ADDENDUM NO. 2

NOTICE TO BIDDERS OF PROJECT NO. 20223 RAY WILLIAMSON POOL IMPROVEMENTS – PHASE 1

Bainbridge Island Metro Park & Rec District: Ray Williamson Pool Improvements

A-1.0
 2208

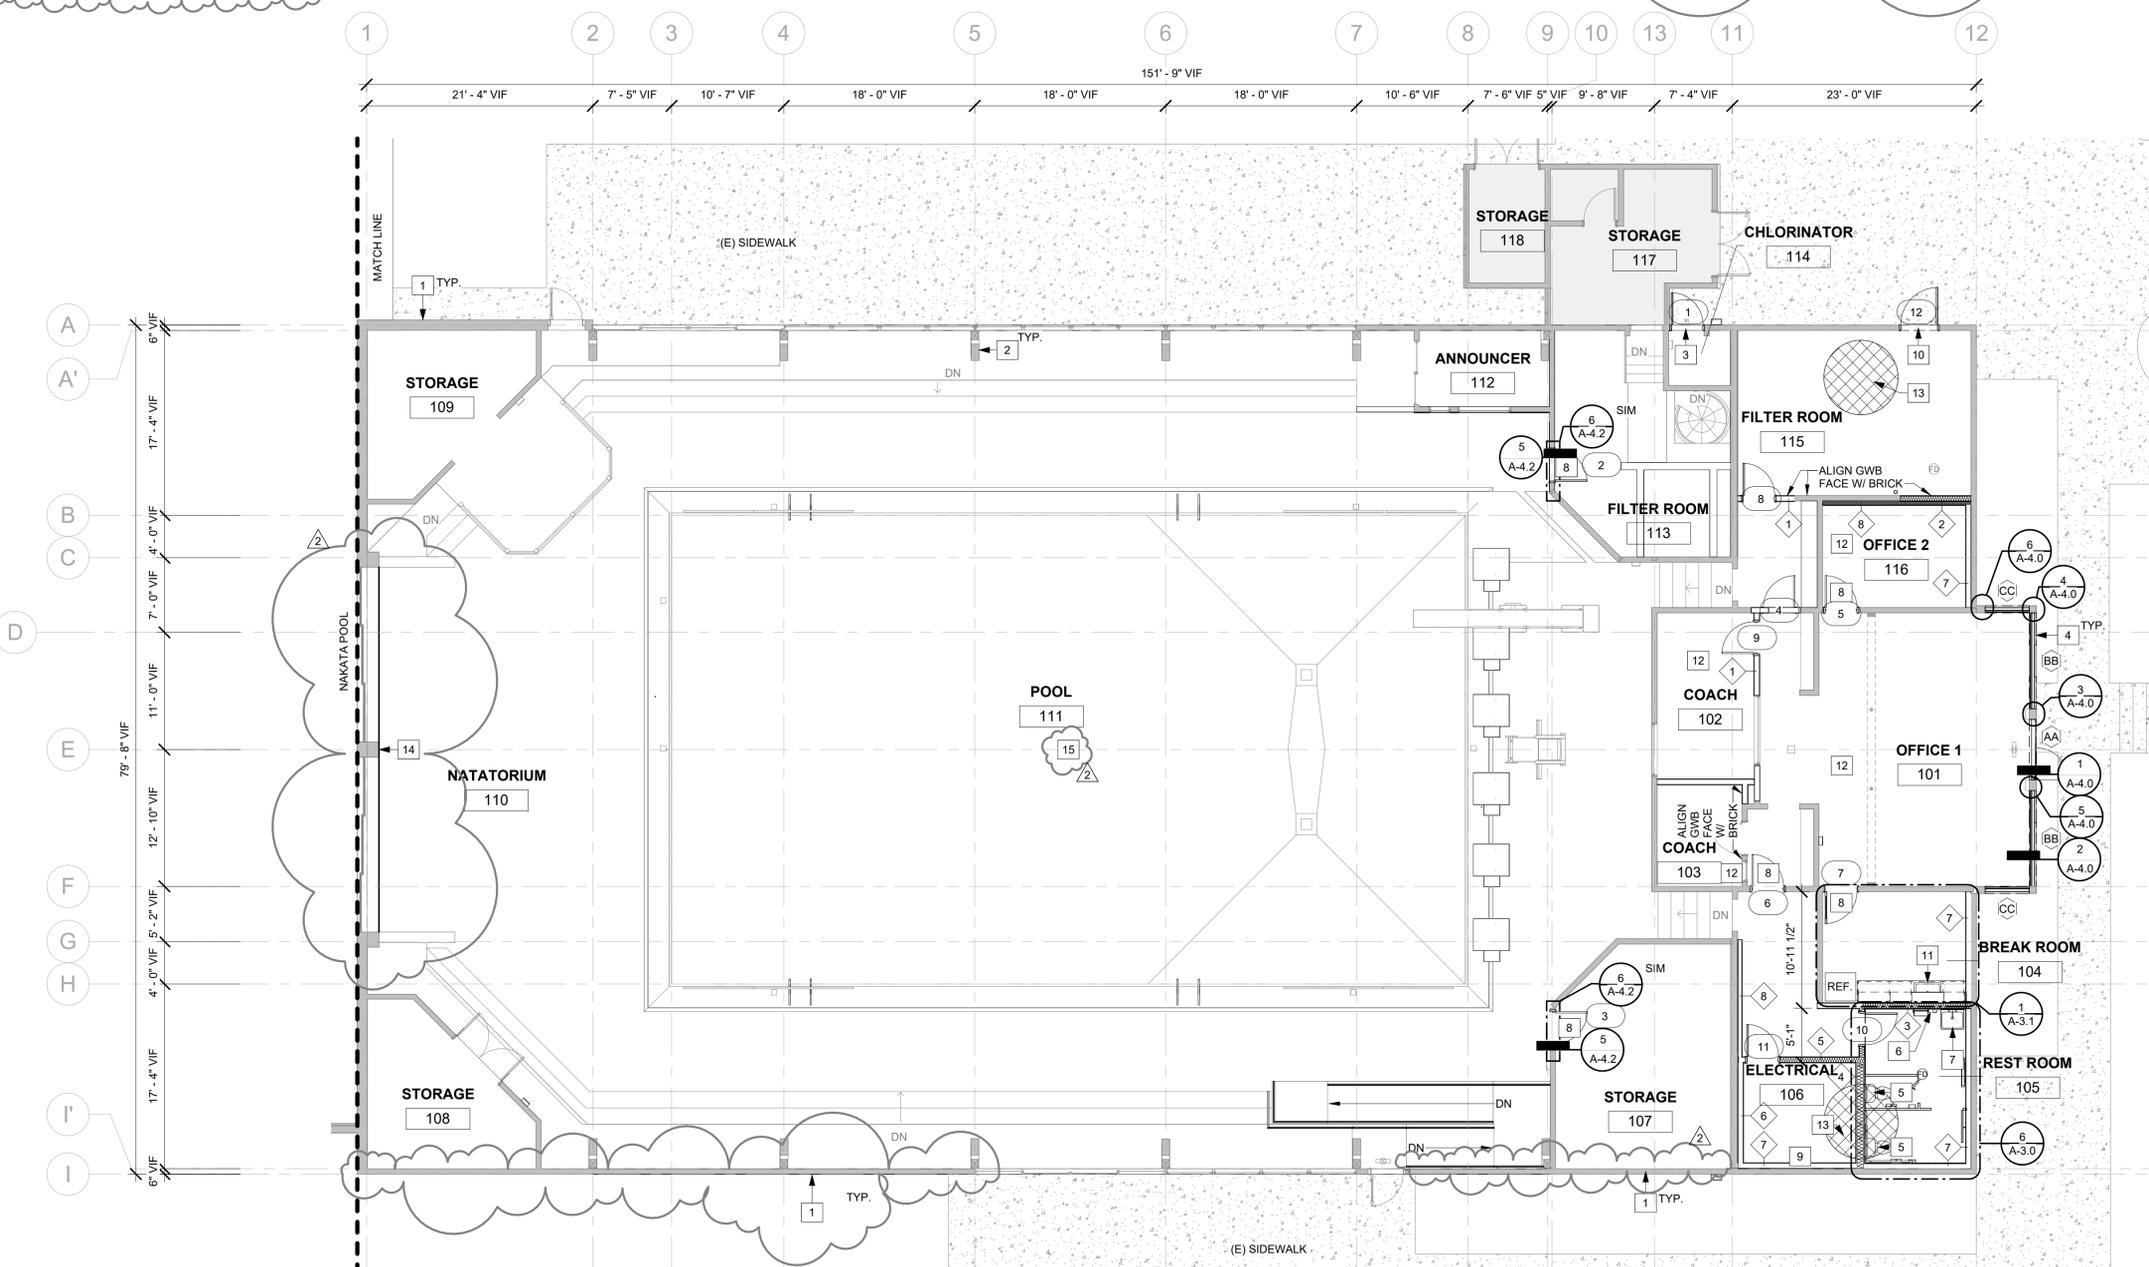
5. **DELETE** sheet A-1.0 Floor Plan and **REPLACE** with sheet A-1.0 Floor Plan in its entirety, attached in Addendum No. 2.
ADD Special Note:
THE NAKATA POOL WILL BE IN OPERATION DURING THE CONSTRUCTION PERIOD FOR THE RAY WILLIAMSON POOL. NO VIDEOS OR PHOTOGRAPHS ARE PERMITTED OF THE NAKATA POOL OR ITS PREMISES AND ITS USERS AT ANY TIME. THE CONTRACTOR AND ALL OF THEIR PERSONNEL ARE RESTRICTED TO THE RAY WILLIAMSON POOL SITE, UNLESS ESCORTED OR GIVEN PERMISSION TO ENTER THE NAKATA POOL SITE.

- DELETE** Keynote No. 1 on Keynote Legend and **REPLACE** with Keynote No. 1.
1. CLEAN EFFLORESCENCE ON INTERIOR AND EXTERIOR OF BRICK WALL. REPAIR (E) DAMAGED BRICK PER STRUCTURAL. APPLY SEALANT AT EXTERIOR AND INTERIOR BRICK WALL.

- ADD** Keynote No. 14 to Keynote Legend:
14. INSTALL PHYSICAL BARRIER AT THE NAKATA POOL AND RAY WILLIAMSON TRANSITION POINT. THE BARRIER MUST PROVIDE VISUAL BLOCKAGE BETWEEN THE TWO POOLS. CONTRACTOR MAY INSTALL VISUAL BARRIER TO (E) STOREFRONT; ANY DAMAGES AND REPAIRS TO THE STOREFRONT WILL BE THE RESPONSIBILITY OF THE CONTRACTOR FOR REPAIR/REPLACEMENT.

- DELETE** Keynote No. 3.
3. REPAIR SPALLING AND DELAMINATED CONCRETE AT FILTER ROOM, REF STRUCTURAL.
- DELETE** 2/A-1.0 FILTER ROOM BASEMENT PLAN

A7: ***Concrete repair work was removed in the basement. See sheet A-1.0 for concrete work in Phase 1.***

A10: ***Seal brick on both exterior and interior per sheet A-1.0.***

A-2.0
2208

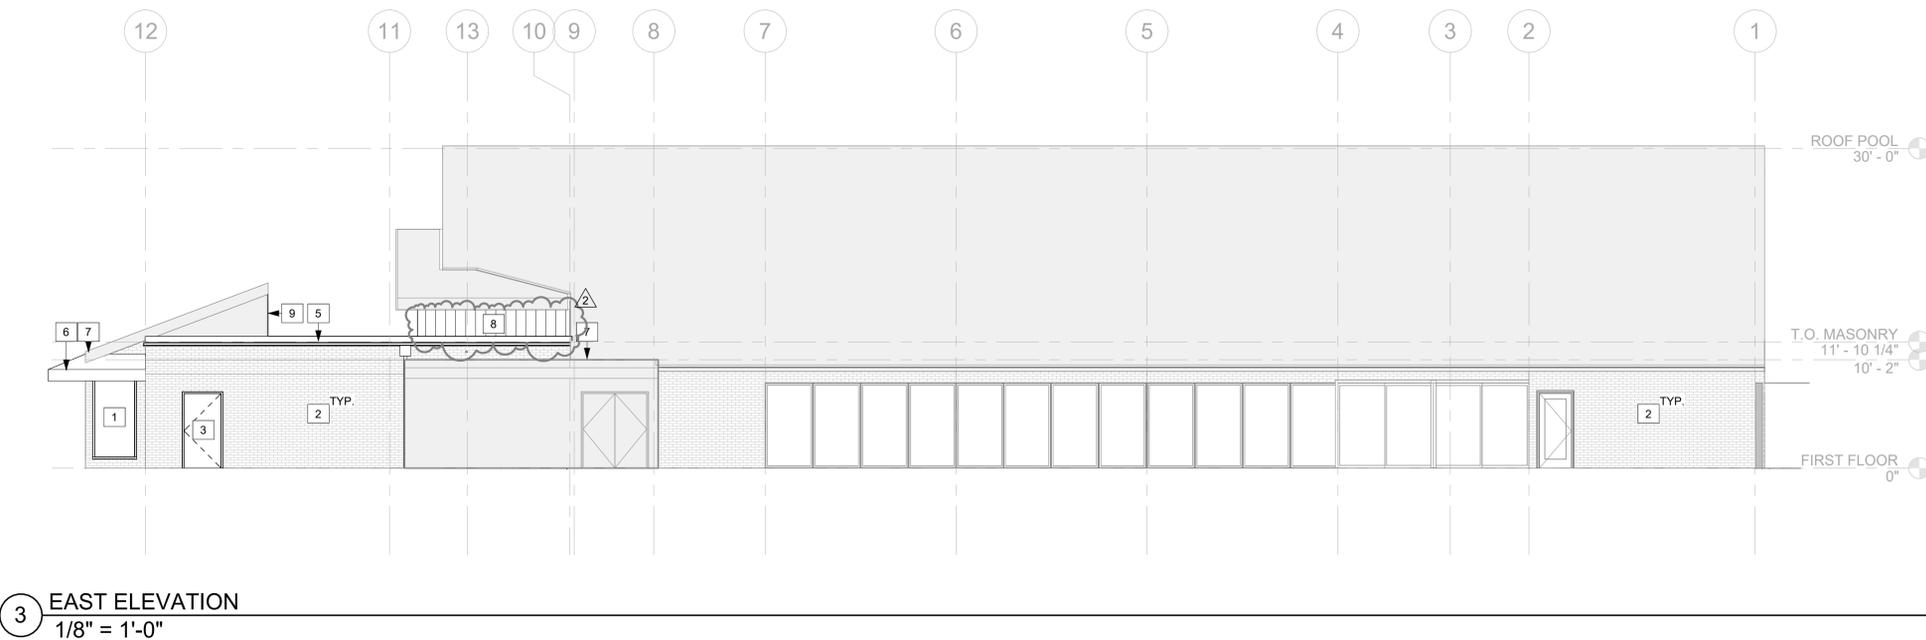
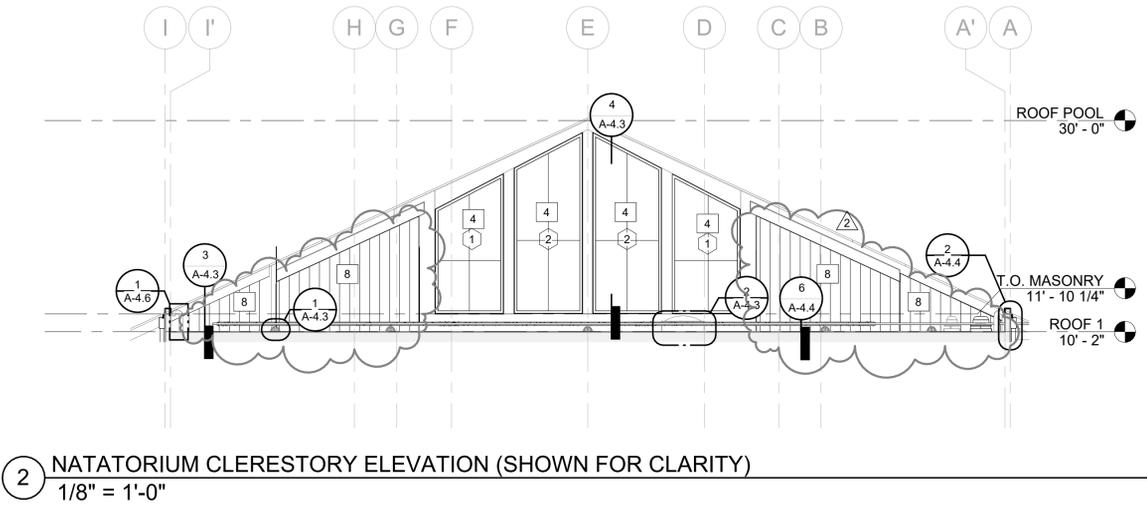
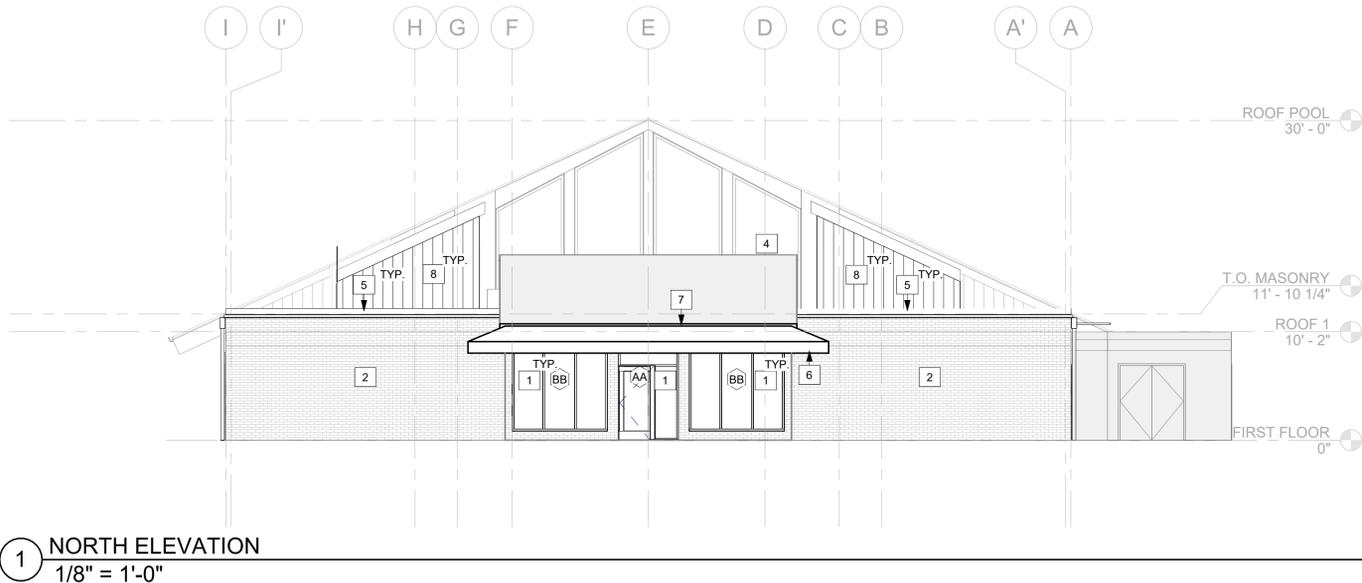
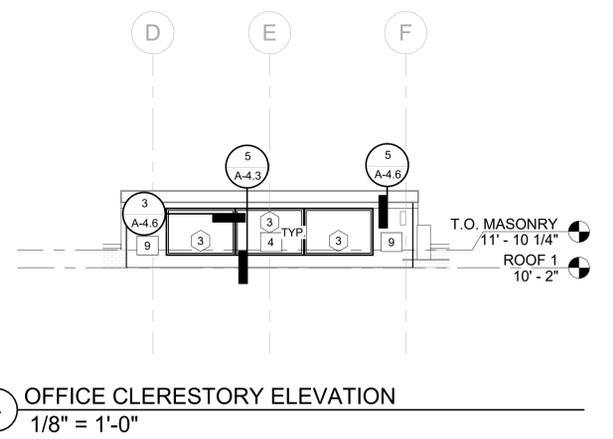
6. **DELETE** sheet A-2.0 Exterior Elevations and **REPLACE** with sheet A-2.0 Exterior Elevations in its entirety, attached in Addendum No. 2.
DELETE Keynote No. 8 on Elevation Keynote Legend and **REPLACE** with Keynote No. 8.

8. FURNISH AND INSTALL NEW T1-11 SIDING AND COUNTERFLASHING.
7. **DELETE** sheet A-2.1 Exterior Elevation and **REPLACE** with sheet A-2.1 Exterior Elevation in its entirety, attached in Addendum No. 2.
DELETE Keynote No. 8 on Elevation Keynote Legend and **REPLACE** with Keynote No. 8.

A5: ***Include replacement of 1500 s.f. of T-111 siding in proposal, see A-2.0.***

A-2.1
2208

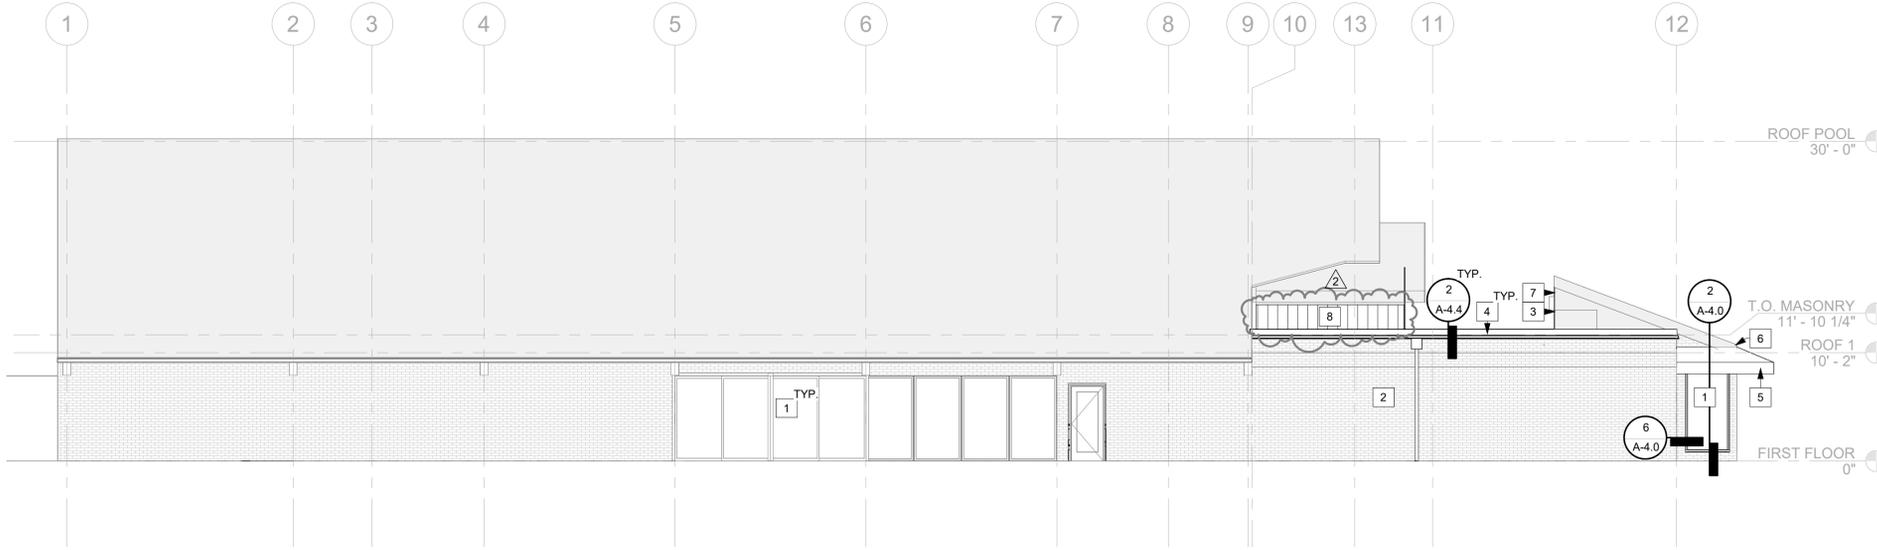
8. FURNISH AND INSTALL NEW T1-11 SIDING AND COUNTERFLASHING.
8. **DELETE** sheet A-4.4 Roof Details and **REPLACE** with sheet A-4.4 Roof Details in its entirety, attached in Addendum No. 2.
ADD note to details 6/A-4.4 and 7/A-4.4 T1-11 SIDING.

ASK1-REFERENCE DETAIL 4/A-4.3

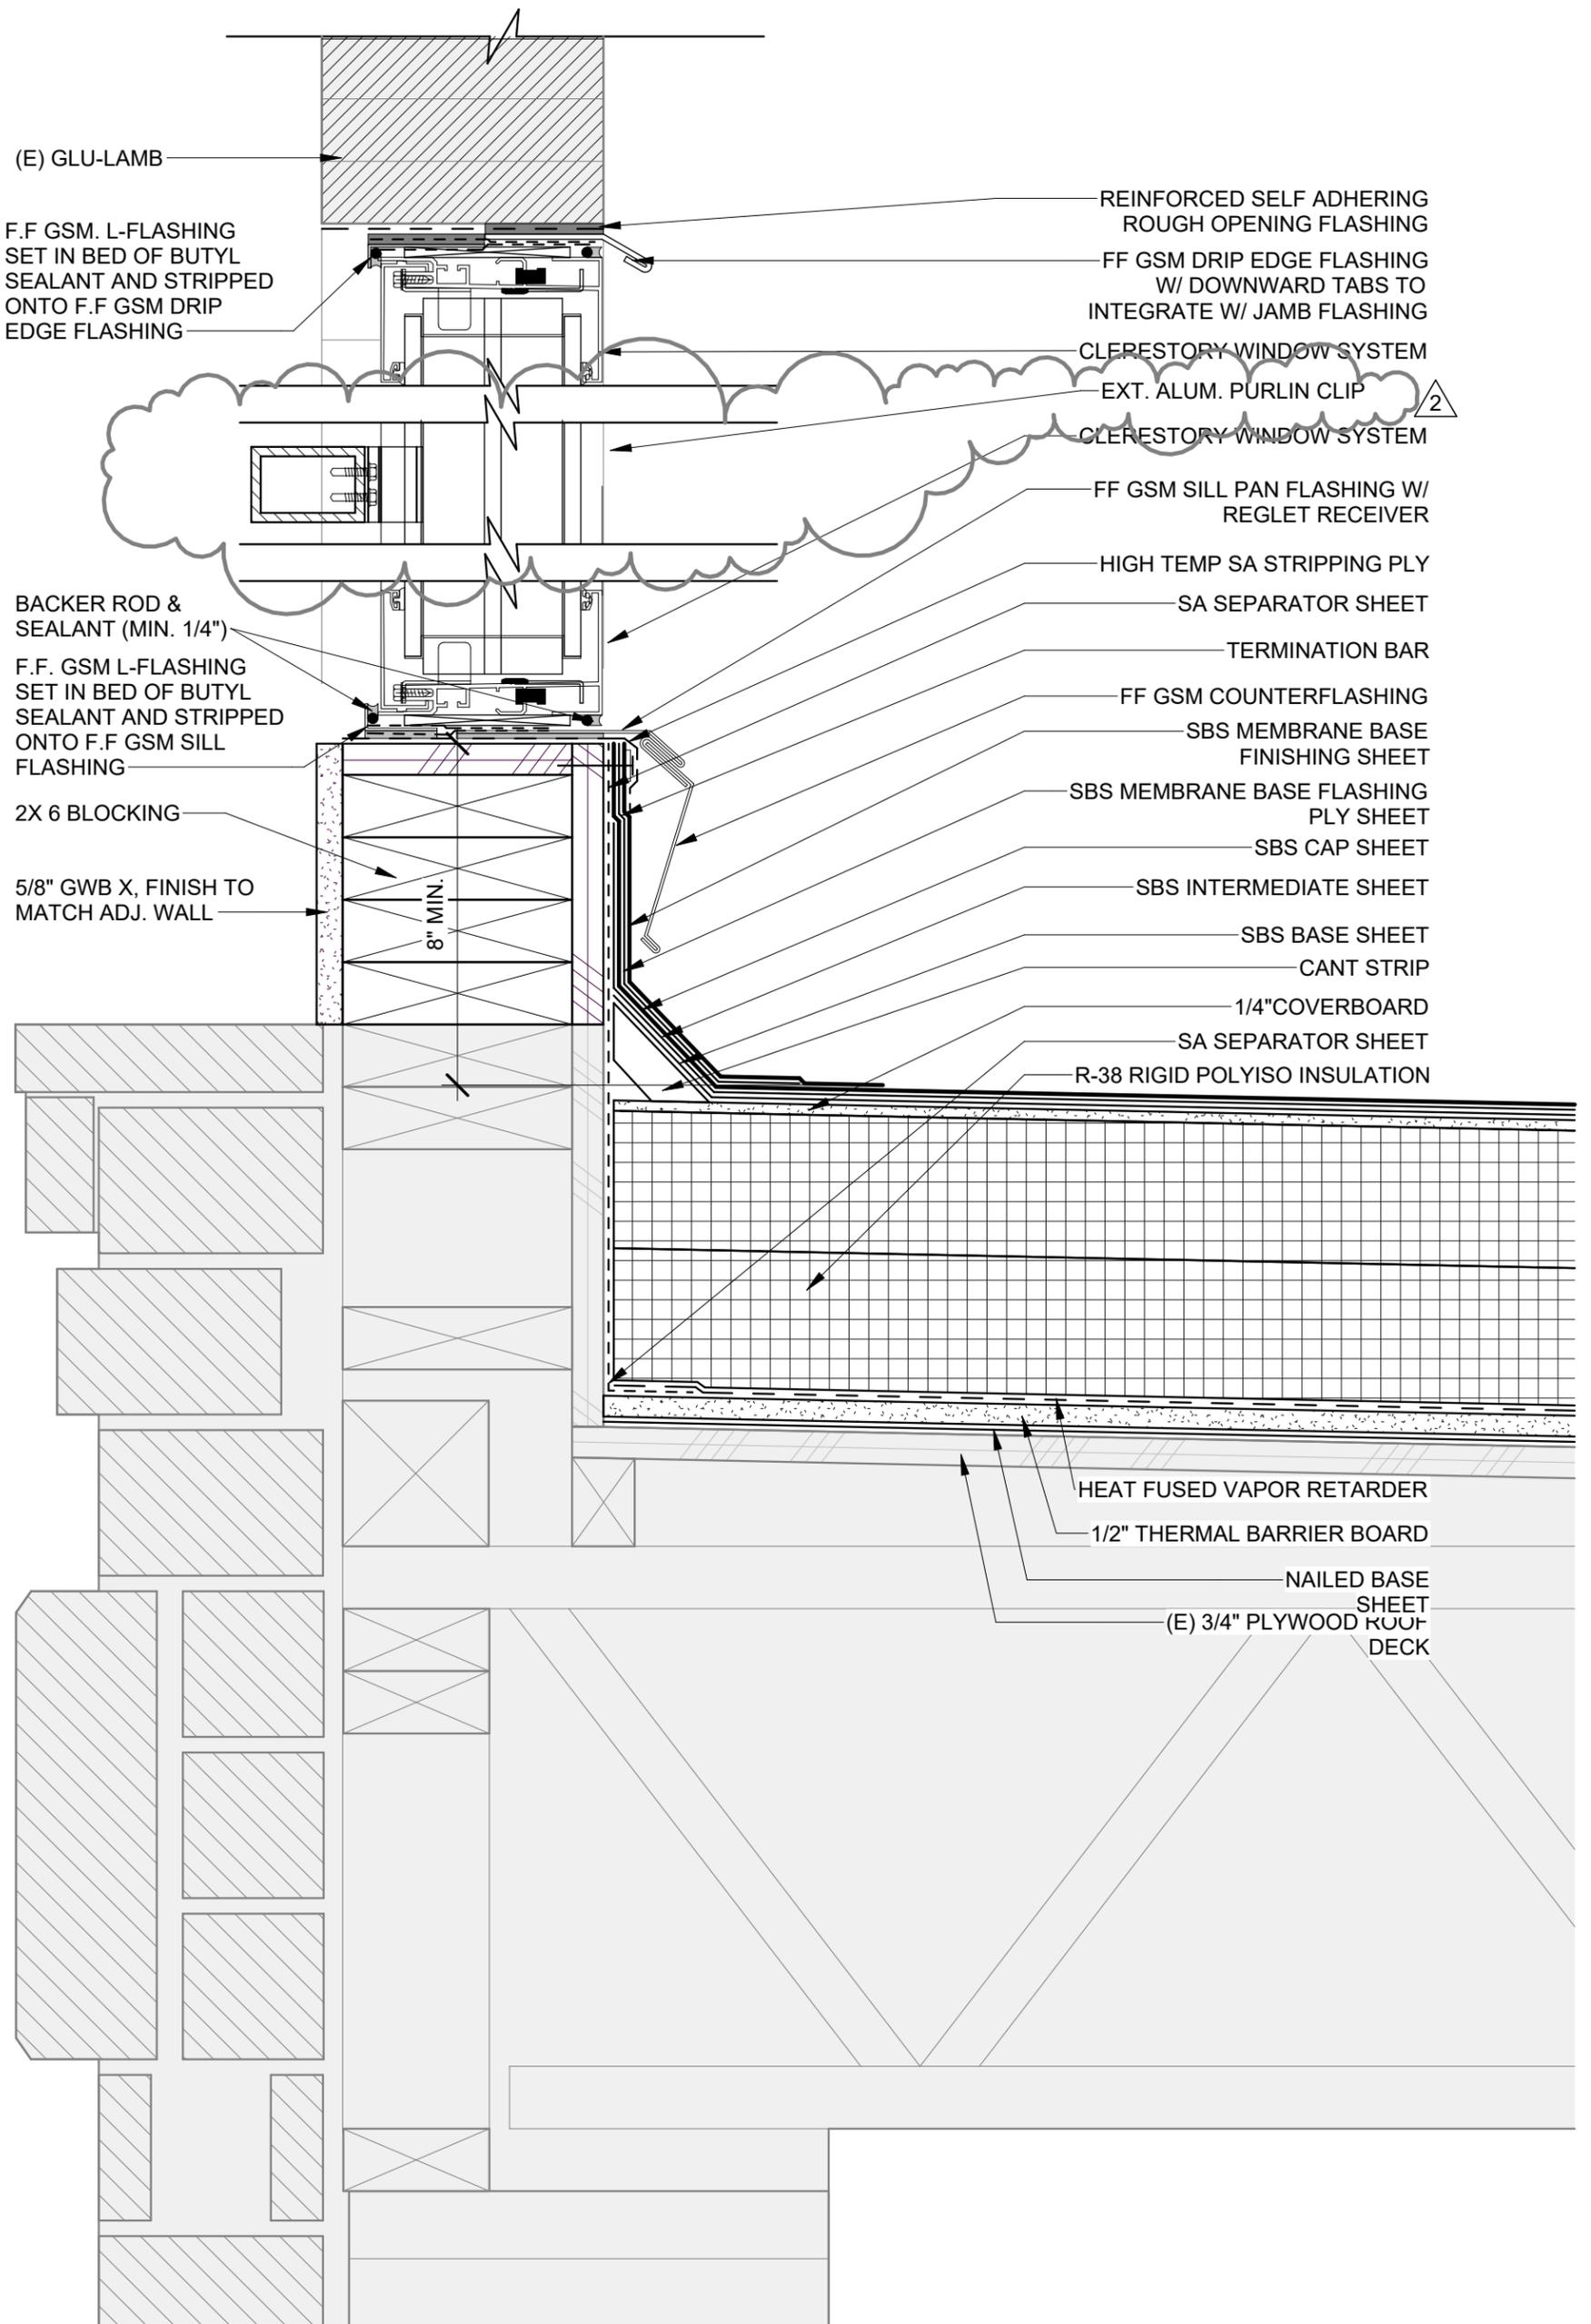
9. Sheet A-4.3 Roof Details
DELETE detail 4/A-4.3 Natatorium Clerestory – CPI Uniquad and **REPLACE** with ASK-1 to with Aluminum Purlin clip, attached in Addendum No. 2.
